Subject: Information Needs To Facilitate 90 Percent Design
Wastewater Treatment Plant (WWTP)
Upgrade and Expansion Final Design

RFI No. 4: Information Needs to Facilitate 90 Percent Design

KJ Project No. 0597002*02

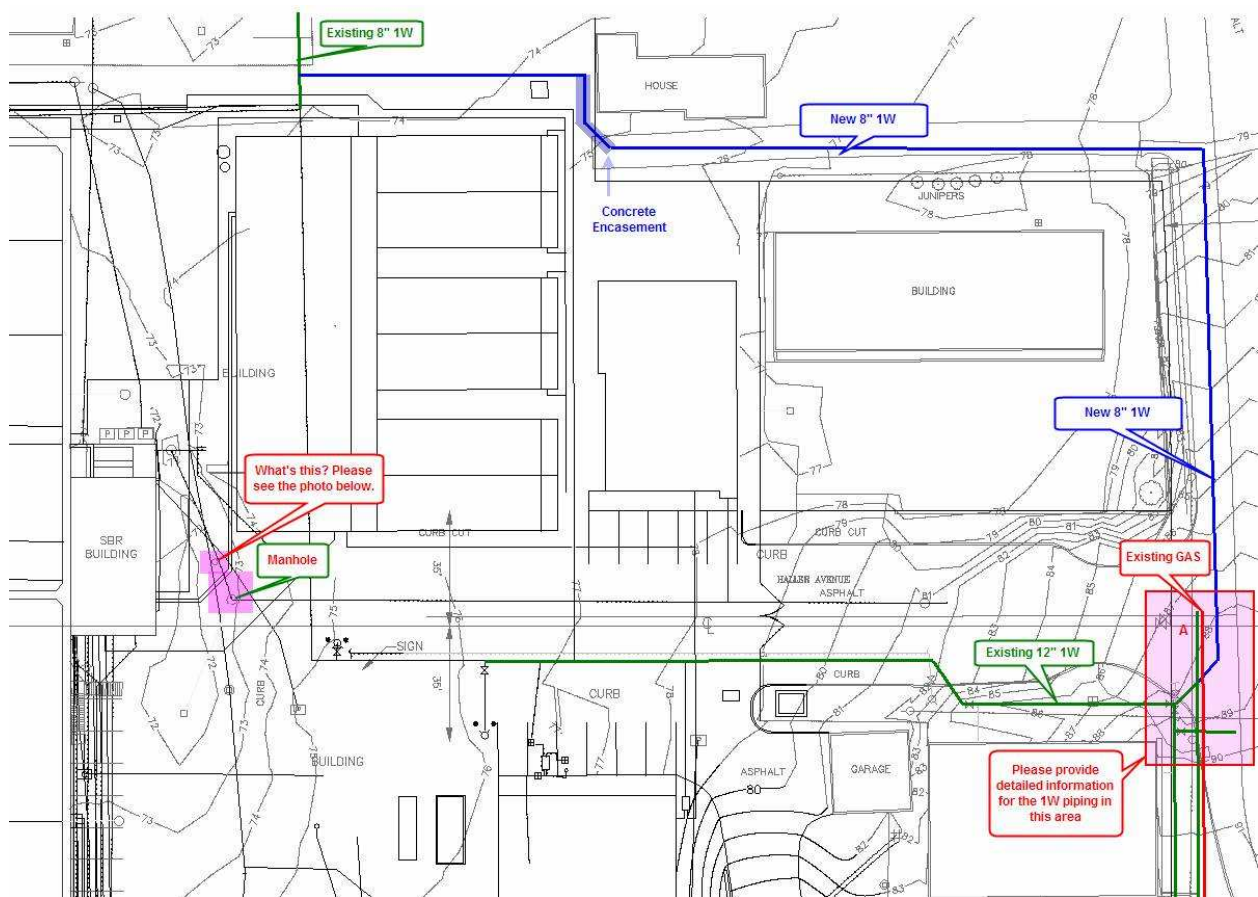
4. **Existing Tie Beams.** The 60% design assumed that the existing tie beams in the SBR basins would be removed, cut to length, and reinstalled to attach to the new longitudinal walls. The structural engineer says that the beams could be left in place, tabs welded to the beams to tie into rebar in the new walls, and the new walls cast around the beams. This would provide a small cost savings. The only disadvantage with this approach is that the top of the tie beams are not flush with the top of the basin and would stick up three inches along the intermediate walkways above the new walls. This could be a potential tripping hazard. This could be somewhat mitigated by welding steel plates on that would ramp up and down from the beams to help provide a transition. Please

provide feedback on whether the City is OK with leaving the tie beams in place. (As an additional note, the baffle walls across the basins that were discussed as being pre-cast sections during the 60% design review meeting have now been changed to cast-in-place, due to the higher cost that would have become necessary with reinforcing the cast sections together for full structural bearing capacity.) **Requested Response:** On or before *Friday, 9 May 2008*.

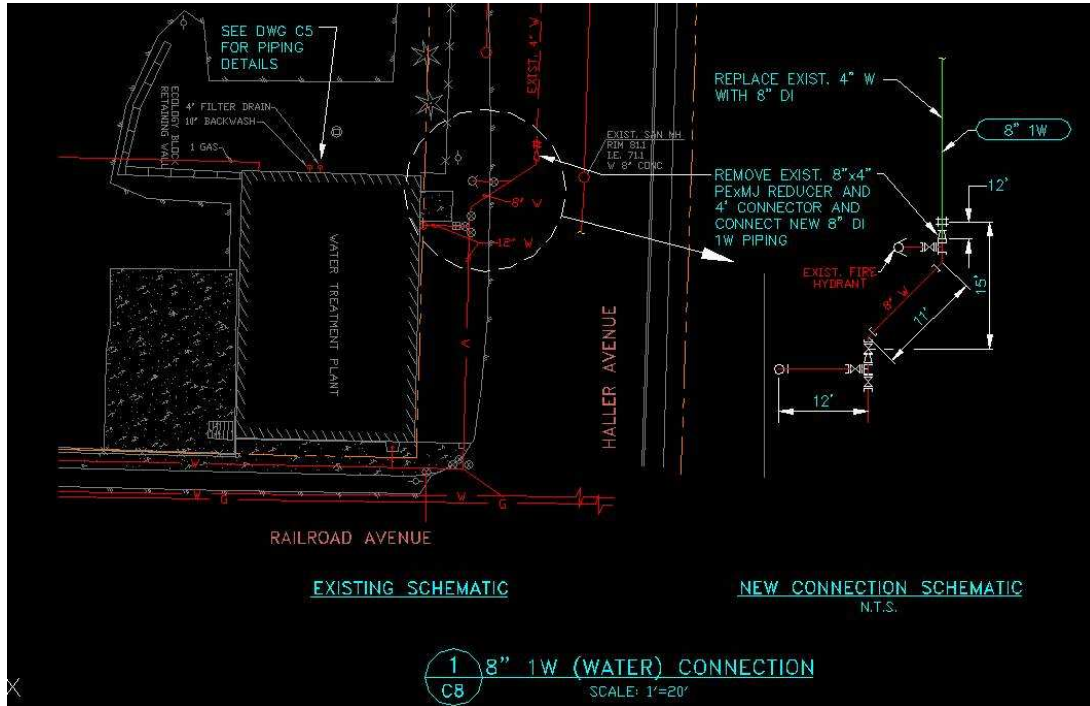
- Existing 1W Piping.** During the 60% design review meeting, it was noted that the alignment of the relocated 1W pipe did not meet the separation requirements. Therefore, we have come up with an alternative alignment (see Figure 1 below).

Utilizing the public right of way in the alley north of the apartments, the alternative alignment achieves the separation requirements, except for a short distance at a pinch point near the northeast corner of the MBR tanks. In this location, we will concrete encase the pipe for the short distance that it is less than 10' clear of the RAS piping. We need additional information on the existing 1W piping in the vicinity of the old water treatment plant to complete the design of this revised alignment. Drawing C10 from the previous upgrade (see Figure 2 at the top of the next page) shows some information, but we need information on the continuation of the 1W line that heads north.
